Suffolk County Council (20031377)

Issue-Specific Hearing 4 (ISH4) Post-hearing Submission

Sunnica Energy Farm (EN010106)

Deadline 7

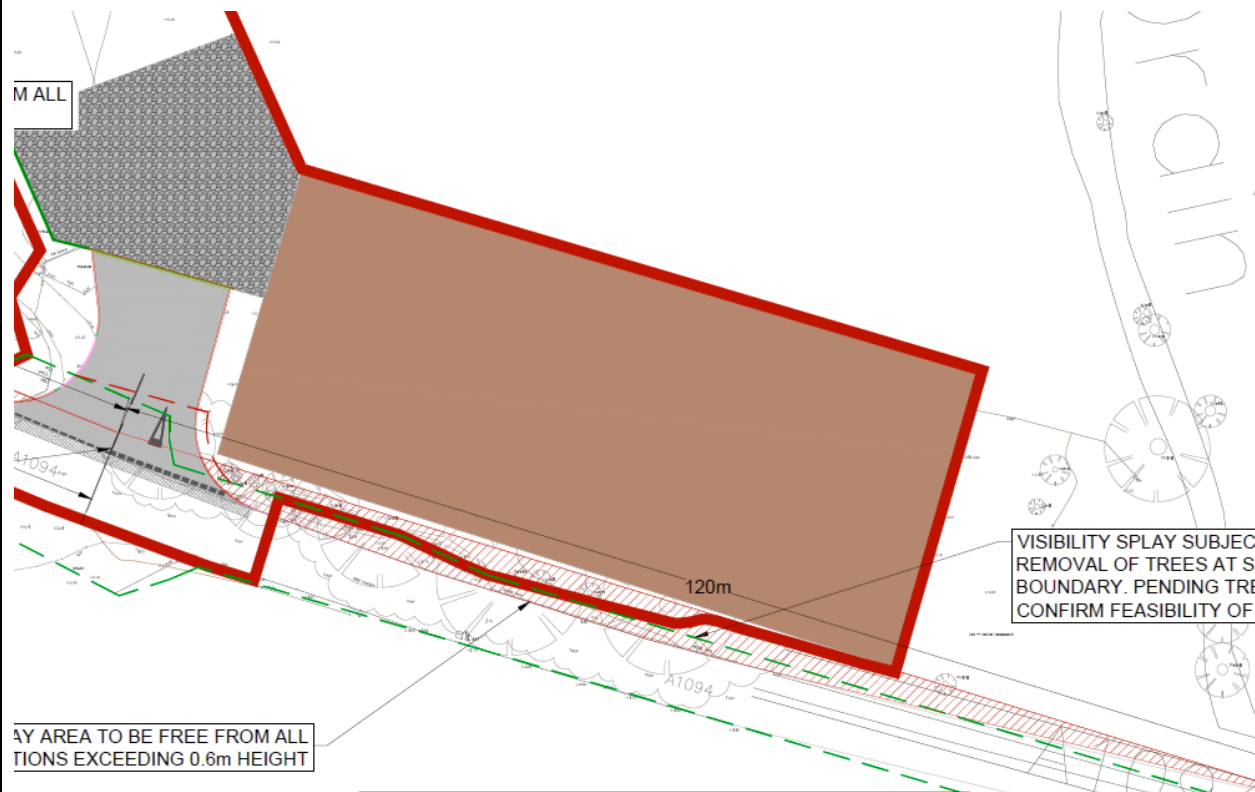
In terms of importance SCC notes that it is currently dealing with an example below where delivery of an DCO access is compromised by the highway boundary (dashed green line) not being coincident with the order limits (solid red line) and hence third-party land is required to provide the necessary visibility splay (hatched red).
